BUTTE REGIONAL TRANSIT OPERATIONS CENTER

Tenant Improvement

ADDENDUM NO. 1

1/4/2016

A603

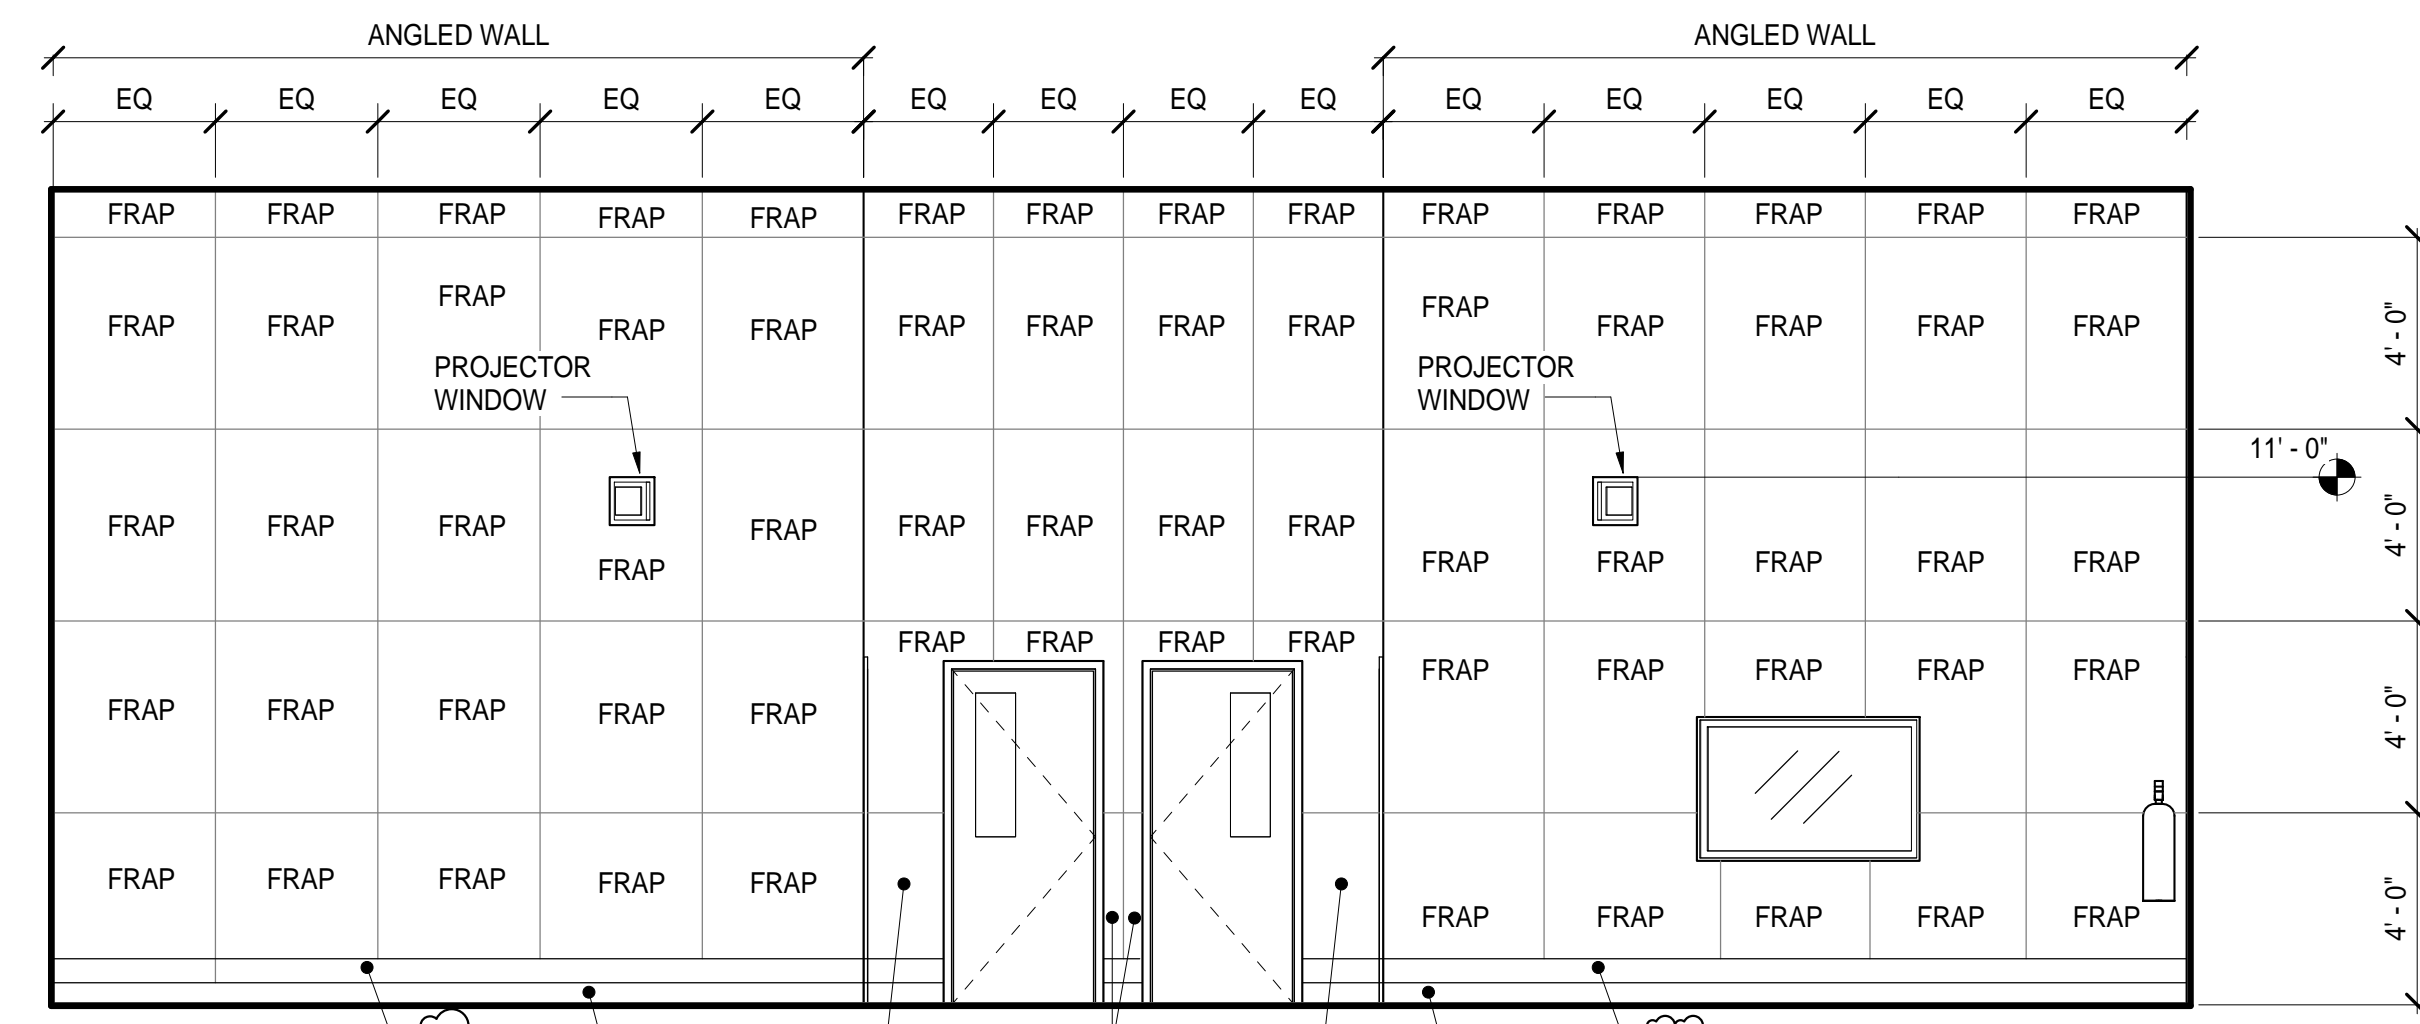
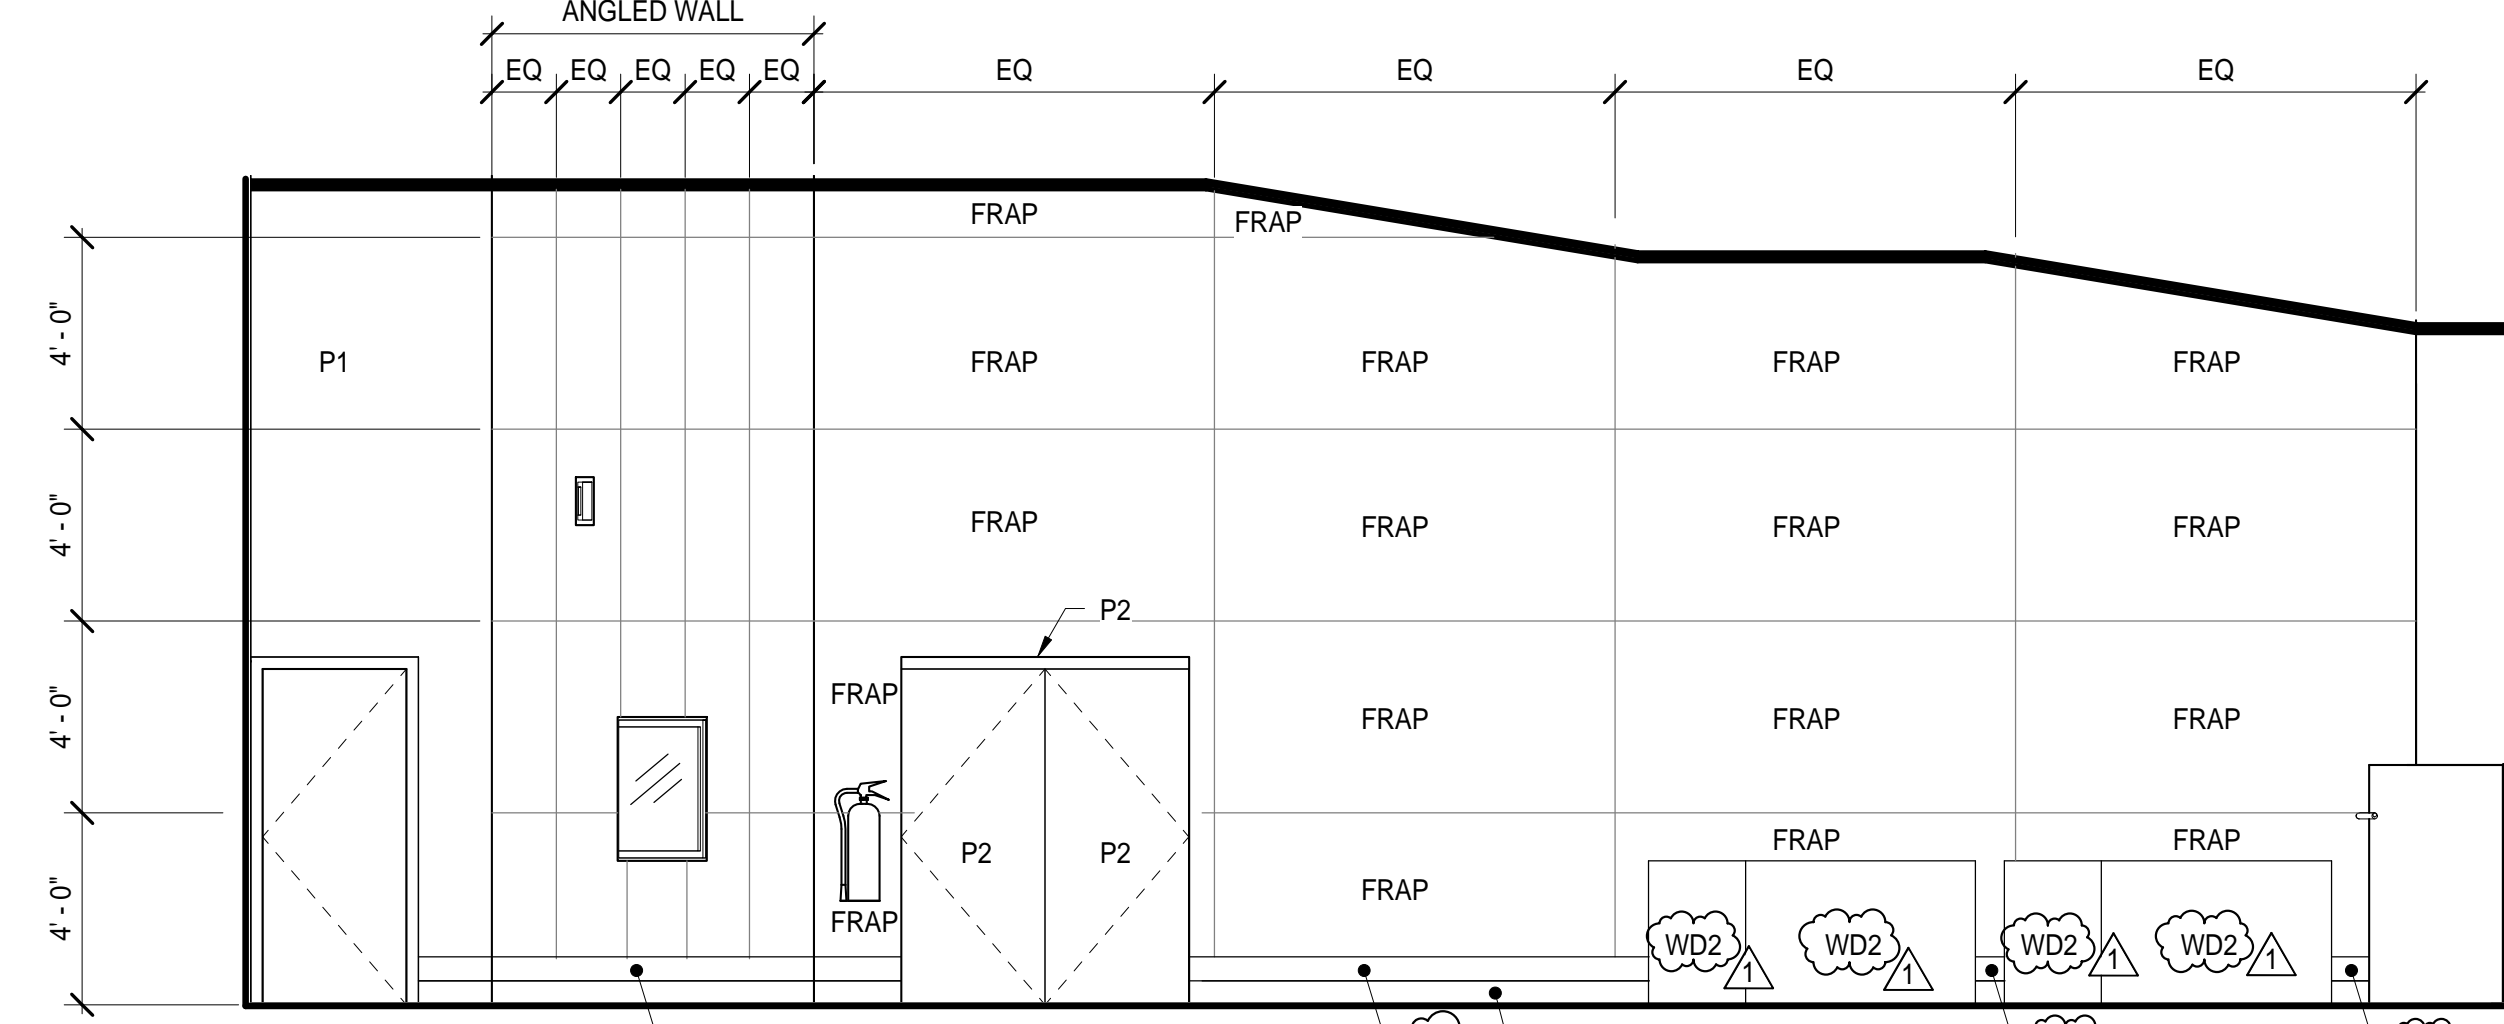
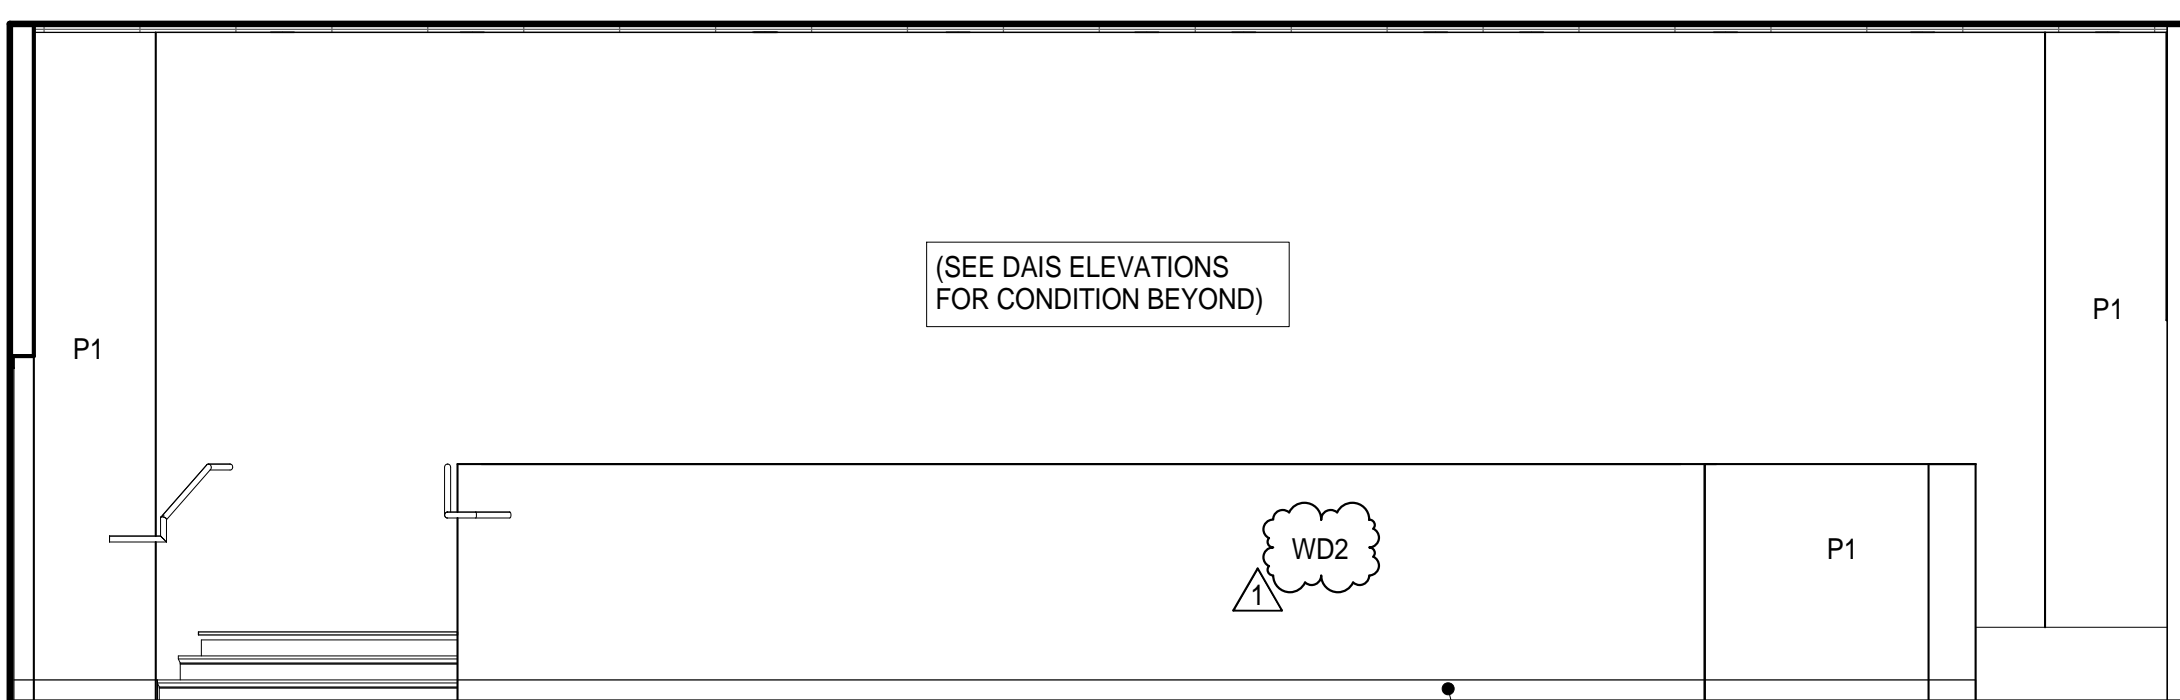
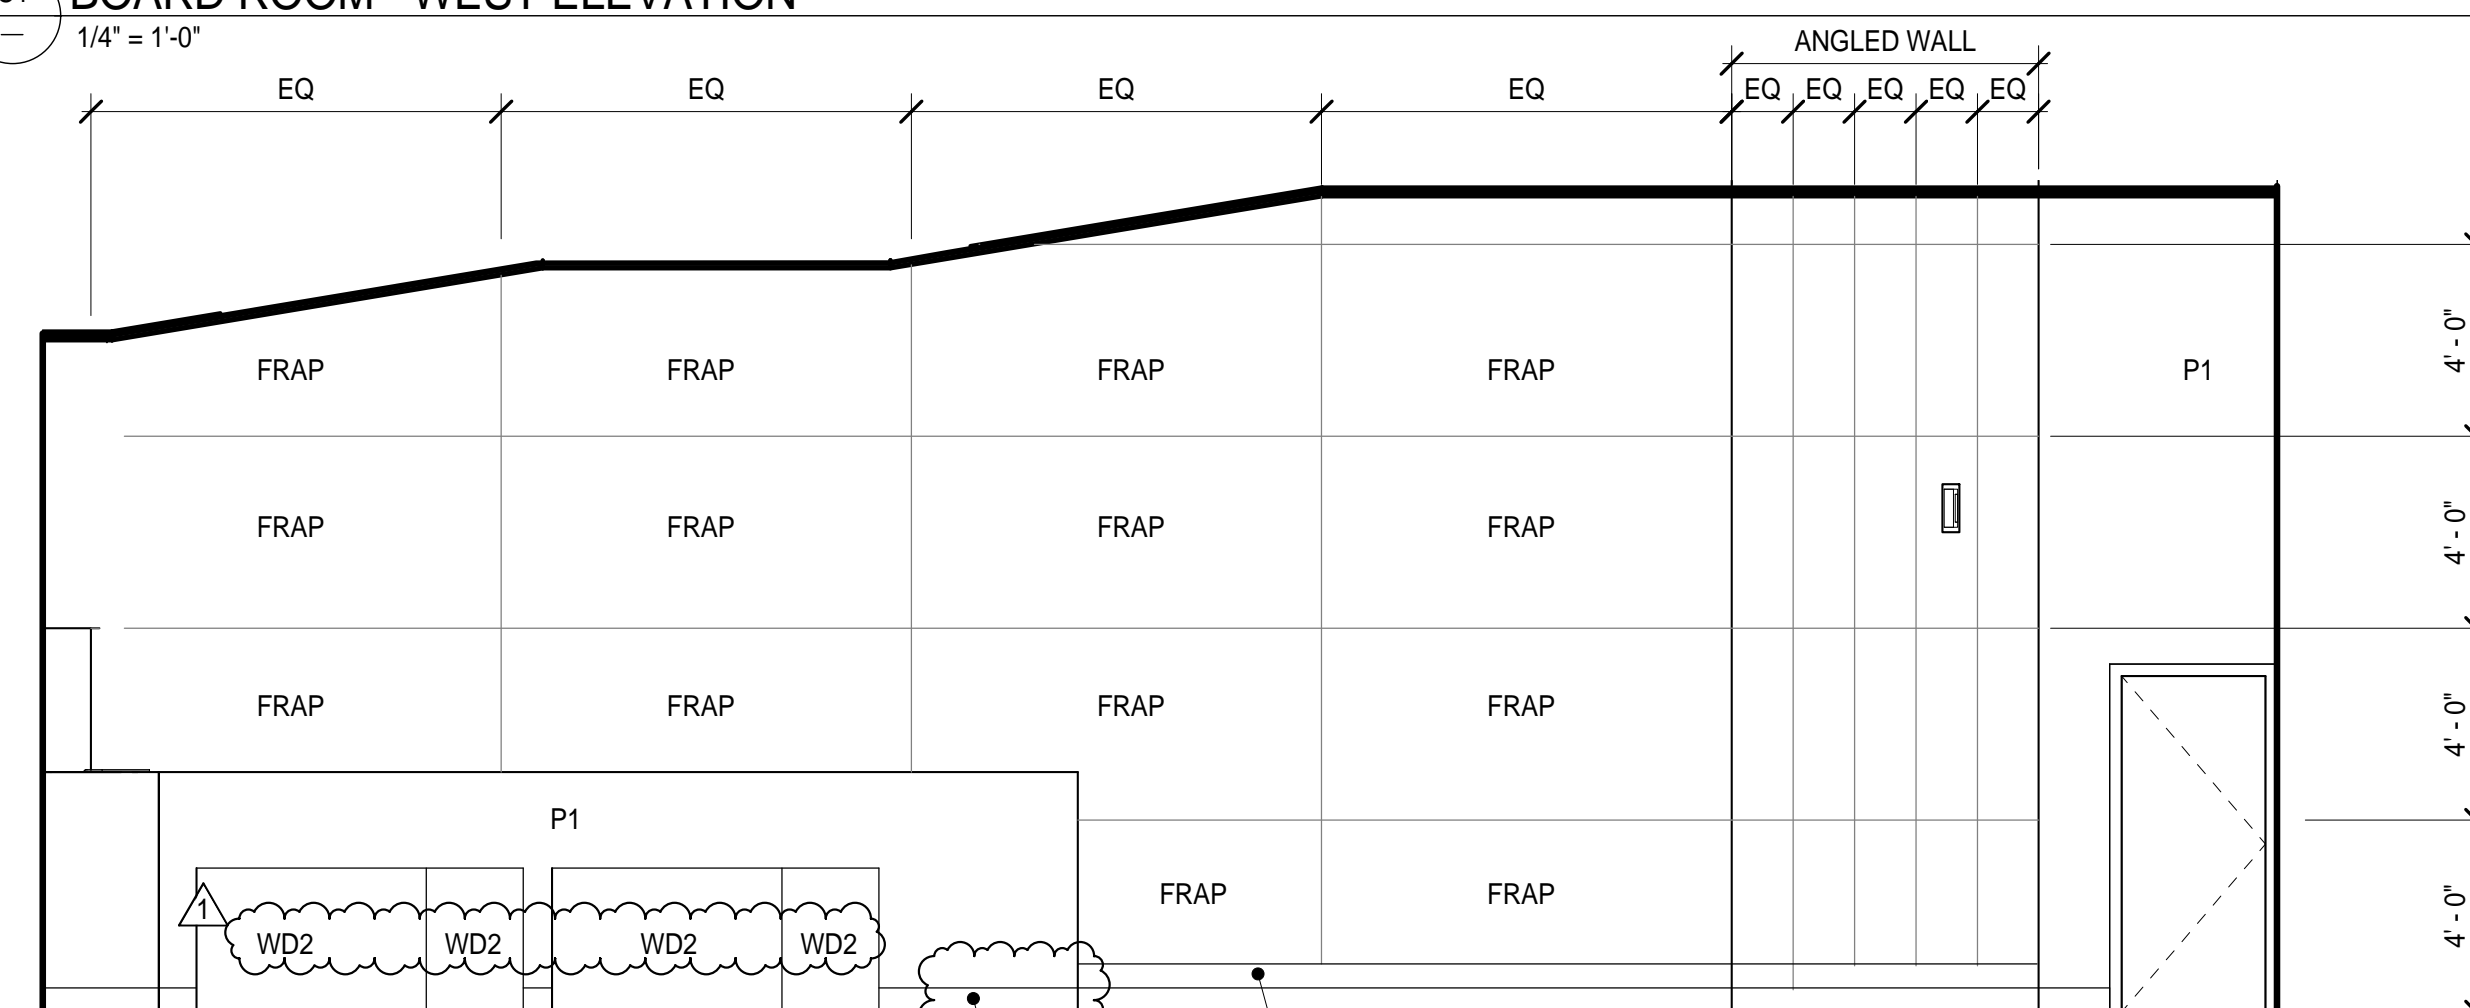
- 1.9 REVISION TO DRAWING A603 - INTERIOR ELEVATIONS
 - a. Elevations C1, C2, C3 & C4 all have clarifications to finishes
- 1.10 REVISION TO DRAWING A604 - INTERIOR ELEVATIONS
